NCPC File No. Z.C. 06-14

**CONSOLIDATED PLANNED UNIT DEVELOPMENT FOR WASHINGTON
GATEWAY AT NEW YORK AND FLORIDA AVENUES,
LOTS 23 AND 811-813 IN SQUARE 3584
NORTHEAST WASHINGTON, DC**

STAFF RECOMMENDATION

CONSOLIDATED PLANNED UNIT DEVELOPMENT FOR WASHINGTON GATEWAY AT NEW YORK AND FLORIDA AVENUES, LOTS 23 AND 811-813 IN SQUARE 3584 NORTHEAST WASHINGTON, DC

Residential Hotel Building North Facade @ New York Avenue

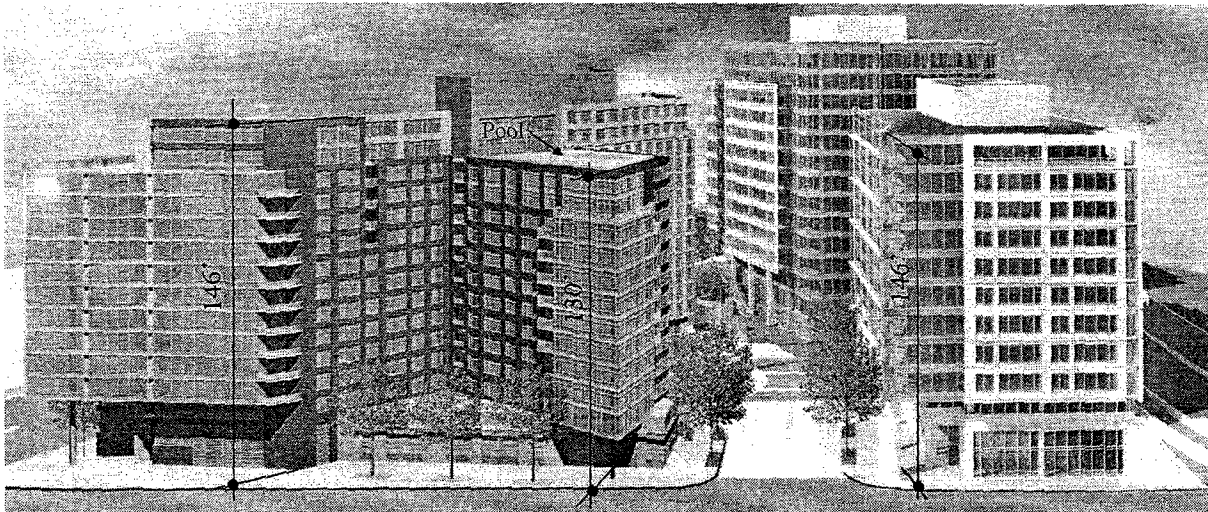
By locating entrances to the parking garage and loading docks immediately adjacent to the intersection of New York and Florida Avenues, the proposed design of the residential/hotel building would adversely affect this significant gateway to the city and diminish opportunities for locating a significant commemorative work in this area.

Although the PUD responds to certain aspects of these policies and recommendations, it ignores other aspects relating to pedestrian activity on the New York Avenue street wall by turning its back on New York Avenue and focusing pedestrian activity, scale, interest, amenities, (ground floor retail and lobby entrances) inward to the plaza and interior street. At the same time, “rhythms at the scale of a single story”, which “occur near pedestrian activity”, occur only interior to the site and at its main (Florida Avenue) entrance where “the double height retail podium angles away from Florida Avenue to open up views of the interior of the plaza.”

Although the PUD design attempts to animate and break down the scale of the New York Avenue street wall by using patterned facade elements, its intent was to be seen “relative to the motion of the vehicular traffic along New York Avenue”, since the street wall has not been designed for pedestrian use. The stair connecting the plaza to New York Avenue attempts to address pedestrians, but only by creating a cut through. With no ground floor retail activity or lobby entrances to buildings, the New York Avenue facade would not be a pedestrian oriented place. The wall between the office building and hotel will block access from the street (it serves as a safety railing) except at the stair opening. Although the avenue’s facades intend visual interest, it is staff’s view that as currently proposed, the New York Avenue street wall pattern alone would not attract pedestrians without retail storefronts or building entrances.

- Modify the building design of the residential/hotel building at the intersection of New York and Florida Avenues to improve the character of this important gateway and potential commemorative works site.

Charrette Concept B Diagram for Transforming the Intersection

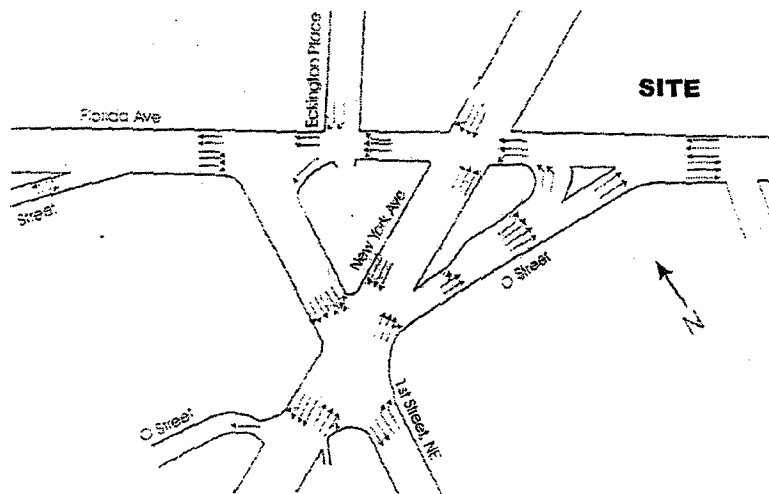
memorial opportunity at the intersection, the other two diagrams (Concept B shown as example) illustrate the current PUD proposal configuration. Staff believes that locating a parking garage entrance and a loading dock entrance in the locations shown in the current proposal is inconsistent with the goal of having a significant commemorative works site at the intersection.

DDOT's Near Term Plan: Virtual Traffic Circle for the Intersection

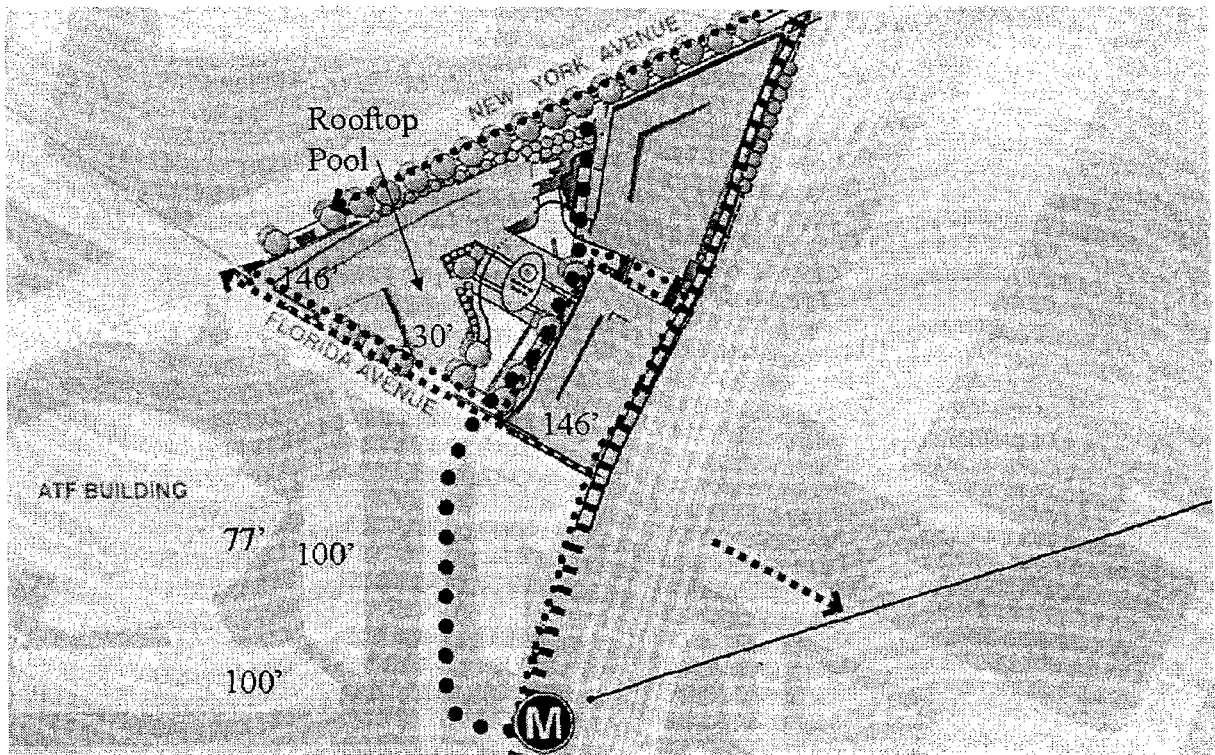
The DCOP staff report further notes that the proposed design is now consistent with the DDOT recommendations for intersection changes as shown in the final Draft New York Avenue Corridor Study. While the PUD design, and even the two curb cuts near the intersection, have been coordinated with DDOT's near term plan to reconfigure the intersection to function as a

virtual circle, the Corridor Study also includes comprehensive urban design recommendations for knitting the city together. The Study calls for special identity focal points to create active pedestrian spaces and help to tie Florida, North Capitol and New York Avenues together, with open space reserved for creation of pedestrian activity at intersection corners. Although as submitted the PUD design for the residential/hotel building notches back slightly at the corner to reveal a covered area, no activity will be programmed. More importantly, the two vehicle entrances in such close proximity to the intersection would diminish opportunities for locating a significant commemorative work in this area.

Relative Roof Heights Above Florida Avenue

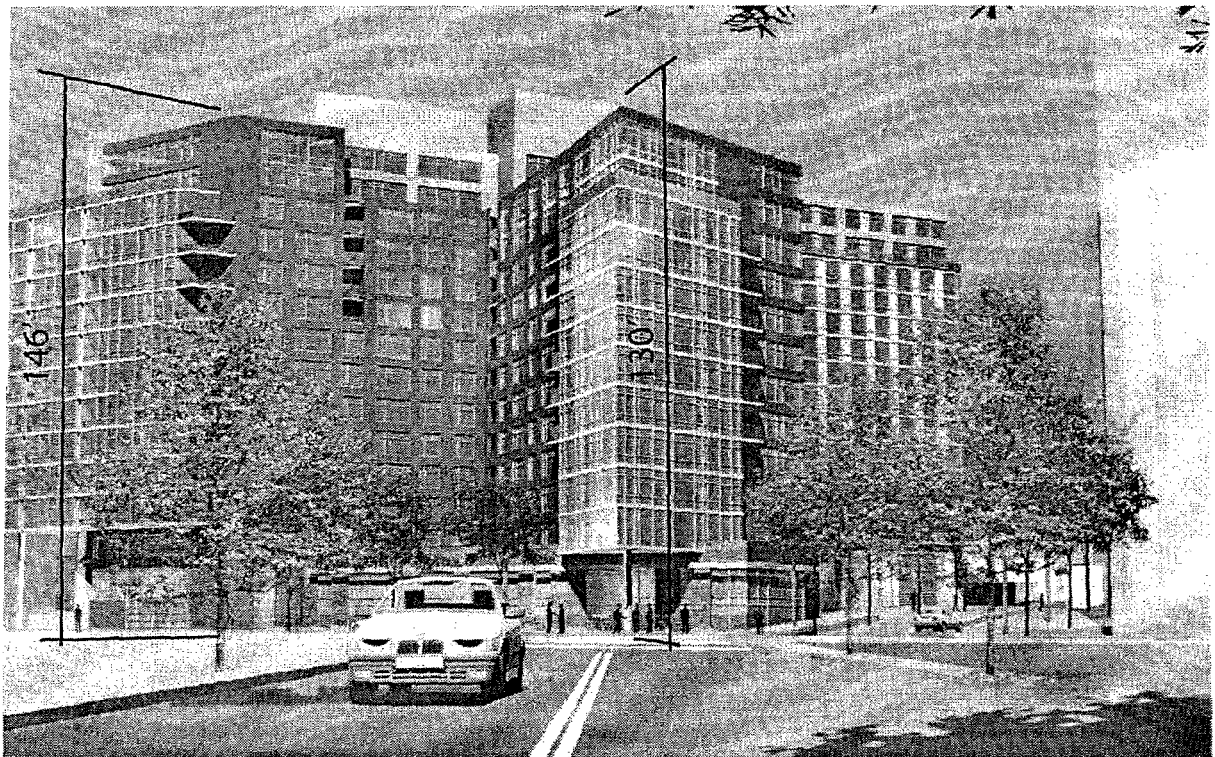
Both office and residential/hotel buildings have heights greater than appropriate for the context, and greater than allowed by the Height of Buildings Act of 1910. In addition, certain aspects of the design of the residential/hotel building would adversely affect this gateway to the city.

By using measuring points along the elevated embankment/approach to the New York Avenue Viaduct crossing the Metrorail tracks, the applicant has acted inconsistently with the intent of the Height of Buildings Act of 1910. In written testimony to the Zoning Commission regarding the Station Place PUD on H Street, J. Carter Brown said "I think it would be a very dangerous precedent for us to sit still for a developer using an additional 30 feet of highway overpass as a kind of credible ground plane from which the maximum allowable height of a building should be measured." In view of NCPC's endorsement of measuring building height at the lower of the natural or finished grade, staff has determined that using a measuring point at the top of the earthen berm is inconsistent with the intent of the Height of Buildings Act of 1910.

Further, agreeing with an August 20, 2003 DC Office of Planning (DCOP) report, the DCZC defined "natural grade" as "the undisturbed level formed without human intervention or, where the undisturbed ground level cannot be determined because of an existing building or structure, the undisturbed existing grade." In a delegated action approved August 6, 2003, NCPC's Executive Director concluded that the proposed text amendment strengthens the intent of the height act and will provide a clear measure of buildings to ensure their compliance with the Zoning Regulations and the and Height Act of 1910. Therefore, staff believes that the buildings should be redesigned to an appropriate height from an appropriate measuring point.

Proximity and Impact on ATFE HQ Building

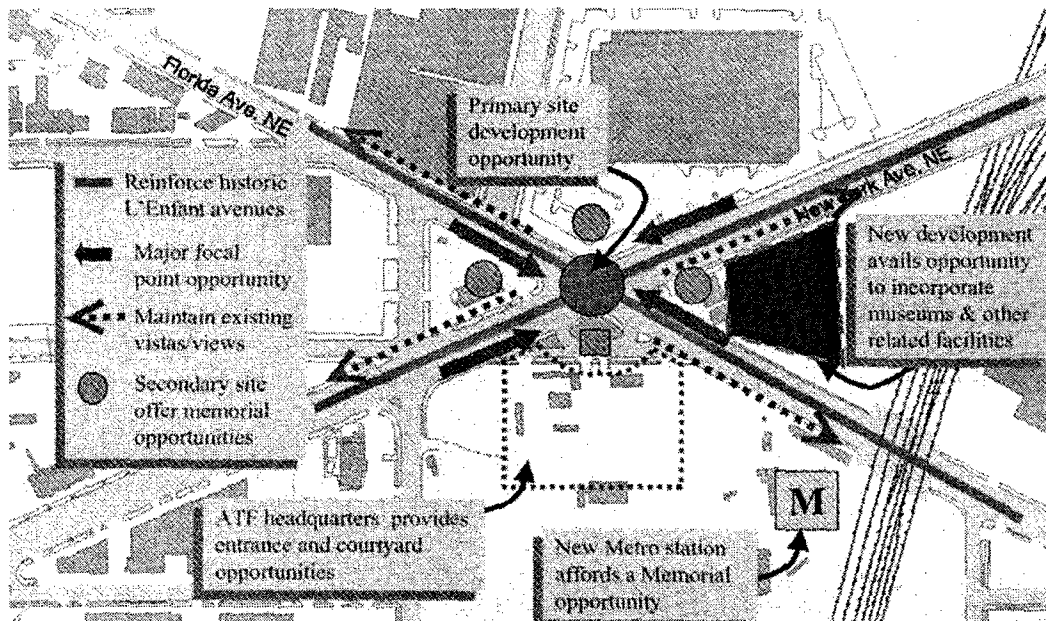
At approximately 146 feet high along Florida Avenue, the height of the residential/hotel building is inappropriate and could create security issues for the Bureau of Alcohol, Tobacco, Firearms and Explosives Headquarters Building (ATF&E HQ). Because the measuring point used is on New York Avenue where it rises to cross the Metrorail tracks, the building height as measured along Florida Avenue across from the Bureau of ATF&E HQ Building is over 130'. The two highest building wings both reach 146 feet above grade at Florida Avenue. The residential wing closest to the Bureau of ATF&E HQ Building is 130 feet above grade with a pool on the roof of the wing closest to 2nd Street. The General Services Administration (GSA) has notified staff that they have security concerns that should be evaluated regarding the height of the project relative to the ATF&E HQ Building through consultation and referral between the applicant and GSA.

- Consult with the General Services Administration and the Bureau of Alcohol, Tobacco Firearms and Explosives to resolve security concerns
